Reference: Nuclear Regulatory Commission [Docket No. 50-361; NRC-2013-00701, Application and Amendment to Facility Operating License Involving Proposed No Significant Hazards Consideration Determination; San Onofre Nuclear Generating Station, Unit 2]

Problem Statement: Two Independent Nuclear Experts Certify that MHI SG Tube Fatigue and Stress Calculations Assumptions are erroneous and based on faulty data – SCE is legally required to certify MHI's calculations to ensure that San Onofre Unit 2 does not pose significant radiological risks at 70% normal steady state power operations during Anticipated Operational Transients and Design Basis Accidents.

Fig-2 Wear Pattern 2

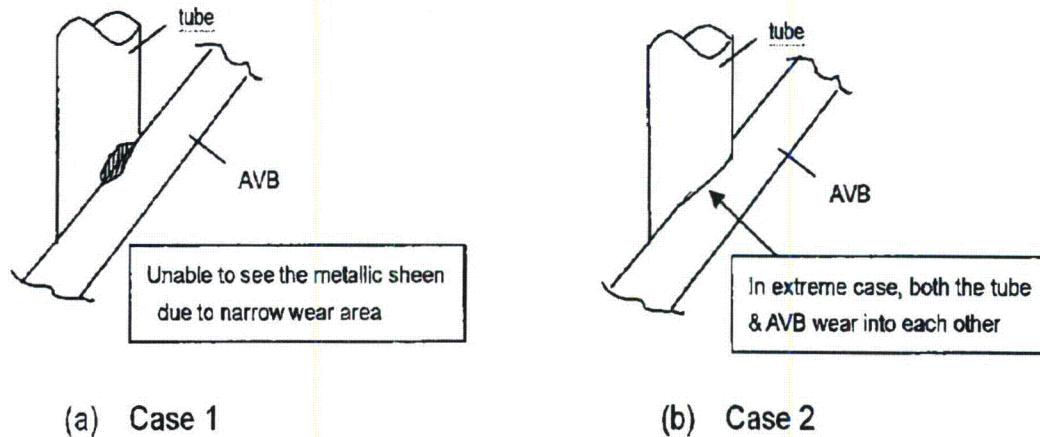
A. In Unit 2 Return to Service Report, Attachment 4, MHI Documents SO23-817-1-M1538, Revision 0, page 288 of 474, Appendix 7, L5-04GA564(9), page 7-9, Figure 2, MHI states, "Section 3.2, Wear Pattern-2 (Local Wear on Tube Surface Characteristics):

(1) Local wear occurs on the tube but the wear surface is not exposed (cannot be seen),

- (2) Unable to determine if wear occurs on tube or AVB or both,
- (3) Unable to determine the direction of motion or vibration, and
- (4) An extreme interpretation is that both tube and AVB are worn into each other.

FIG 1 – COMPARISON OF THE MHI CALCULATED STRESS WITH THE STRESS CALCULATED IN THE CPUC REPORT

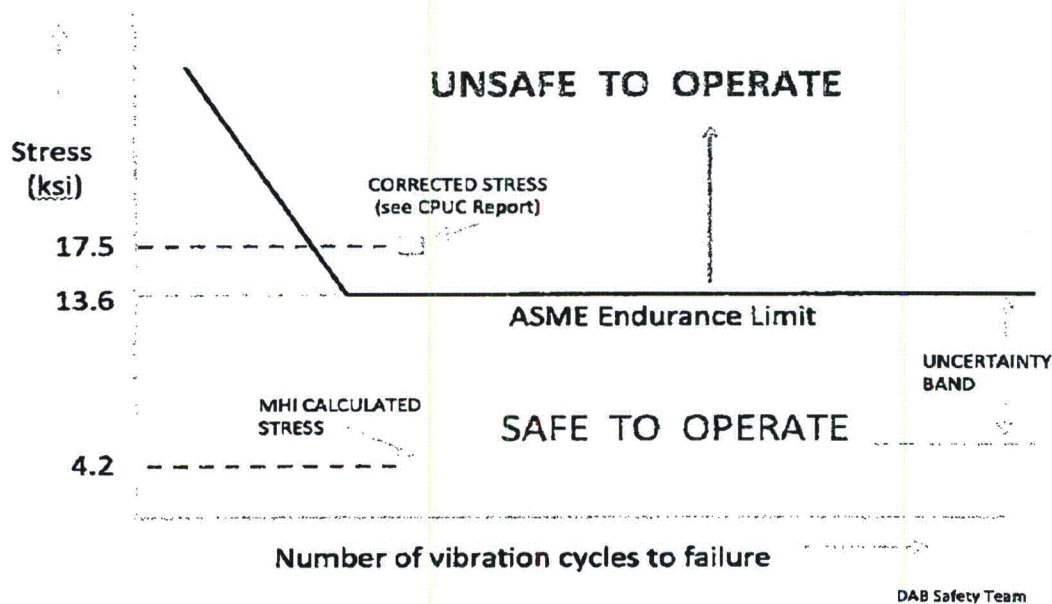
C. The source of MHI's error described below resulted from how they calculated the increase in the local stress at geometrical discontinuities (notches), which are formed when two metal surfaces come in contact during vibration. Since the worn surfaces of the tubes inside the steam generators as shown in Figure 2 above cannot be seen, MHI made two incorrect key assumptions, which are inconsistent with the observation that both the tube and the supporting bar are worn into each other. First, MHI assumed that the ASME endurance limit could be applied directly to the notched tube surfaces. Since it is commonly known that surface roughness significantly reduces fatigue life and since the ASME data is for smooth polished surfaces, this assumption would underestimate the amount of fatigue damage. Second, when using the Peterson chart, MHI assumed an unrealistically large fillet radius and consequently derived a low concentration stress factor. Large radii would decrease the local stress and cause the tube to fail at a higher level of stress, thereby increasing its fatigue life. Only by using these two, arbitrary, non-conservative-assumptions was MHI able to conclude that Unit 2 did not suffer any fatigue damage.

Fig. 6-4 Wear shape of tube at the contact point with AVB

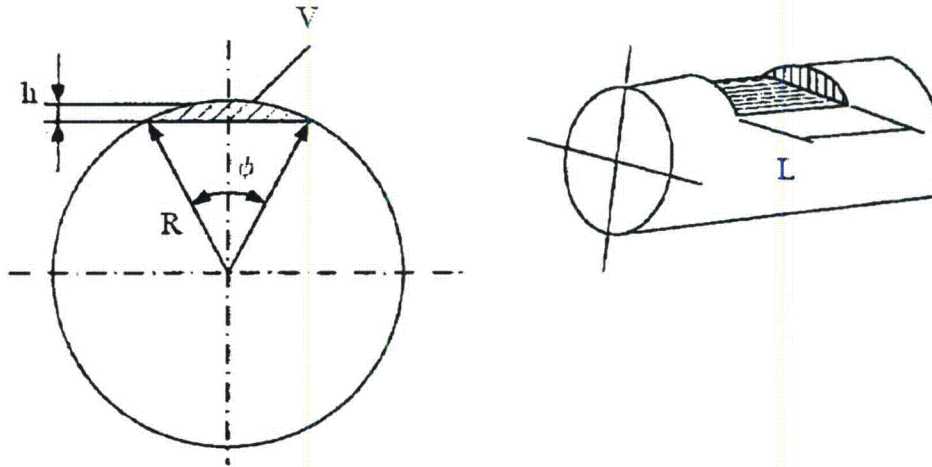
As depicted in the MHI Figure 6-4 below, the support bar and the tube form a sharp discontinuity at the contacting surface, therefore the appropriate geometry for calculating the stress concentration is an abrupt geometry change (very small radii or zero radii of a notch in accordance with RG 1.121), not a large radius shoulder fillet that was assumed by MHI. When a correction is made to account for the sharp notch, the corrected stress indicates (See Figure 1 above) that the tubes have used up their fatigue life during the first cycle of operation. Structures with sharp notches can fail catastrophically when subjected to high cycle fluid elastic instability and flow-induced random vibrations. (MHI redacted their assumption so the exact value of the radius they used is unknown.)

- (Page 10-20, Item (7)) "Wear Calculation: Experimental correlations between the metal loss and the work rate are used to calculate tube metal volume reduction. The relation between wear volume (V) and wear depth (h) is represented as follows: (a) Tube to AVB wear and Tube-to-Tube wear: The tube thickness reduction is then calculated using the wear properties and work rate parameter as assuming the wear configuration as shown in Fig.6-4. The wear width of tube to AVB wear is assumed to be the same as the width of AVB.

Note: Both the impact and the sliding motions play a part in the tube/AVB interaction. These factors reduce tube strength because of material loss and loss of fatigue strength.
